**Submission to Sydney East Joint Regional Planning Panel
Shearwater Landing, Greenhills Beach
Staged Residential Subdivision proposed by Breen Property
2012SYE065 - DA12/0476**

This submission to the JRPP has been prepared on behalf of the applicant to address particular issues that have been raised in Sutherland Council's Supplementary Assessment Report and Recommendation and the associated revised Draft Conditions of Consent.

Figure 1 - Section through Wanda Beach and the site showing that future dwellings cannot be seen from the waterline due to the height and location of the foredune.

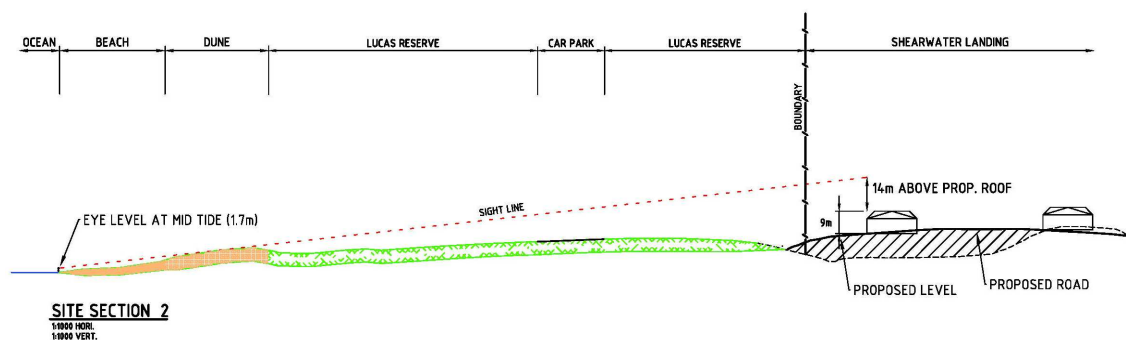
The second key characteristic of the ridge line is its potential visibility from Wanda Beach and the associated reserve. A survey was undertaken to determine the existing levels of the beach, foredune area, Wanda Reserve and the site¹. This survey information was used to prepare a section, as shown in **Figure 1** below.

This section confirms that neither of the landforms proposed by the proponent or Council are visible from the waterline of the beach directly in front of the site, nor from the beach above the waterline. Therefore, further lowering of the ridge as recommended by Council will have no practical effect in terms of views from Wanda Beach.
